Cobra 138XLR Technical Bulletin 1216

COBRA FIELD BULLETIN

SUBJECT: TR-36/R153 Crystal Drift Correction Modification Cobra 138XLR.

FIG. 1.

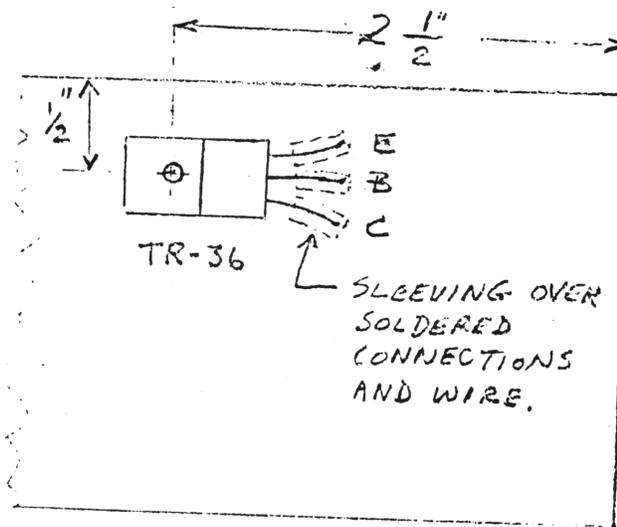
SYMPTOM: After the radio has been on a period of time, high temperatures are generated by TR36 & R153 causing excessive heating of the SSB crystals in the near proximity. This will appear as excessive transmitter or receiver drift on SSB operation.

1. Remove R153 56ohm 2W resistor. Replace resistor with a piece of the #22 AWG solid copper wire on P.C. board.
2. With the controls facing you, the component side up, remove TR36 ZSC1419B and relocate by mounting with a mica insulator, insulating shoulder washer, Phillips head screw, and hex nut, on the right side of main chassis (near mike connector).

1. Drill or punch a 1/8 inch diameter hole on the right side of the main chassis, near mike connector, 2½ inches from front edge of chassis and ½ inch from top. Be sure all drilling chips are removed from the radio. Any burrs in component side of hole must be removed by chamfering tool or other means.
2. Apply a small quantity of heat sink paste (Wakefield Thermal Compound) to both sides of the mica insulator and mount horizontally against the chassis. Then mount TR36 against the insulated shoulder washer, screw and nut. Make sure the shoulder on the insulating washer seats in the hole in the transistor heat sink.
3. Cut three pieces of #22 AWG stranded teflon or vinyl covered wire, colored orange, green and violet (or substitute colors

as required) into 6" lengths. Strip insulation 3/8" of each end and tin. Then mount each wire to the emitter-base collector of TR-36 and the opposite ends to the corresponding points on the P.C. board where the TR-36 transistor was previously mounted.
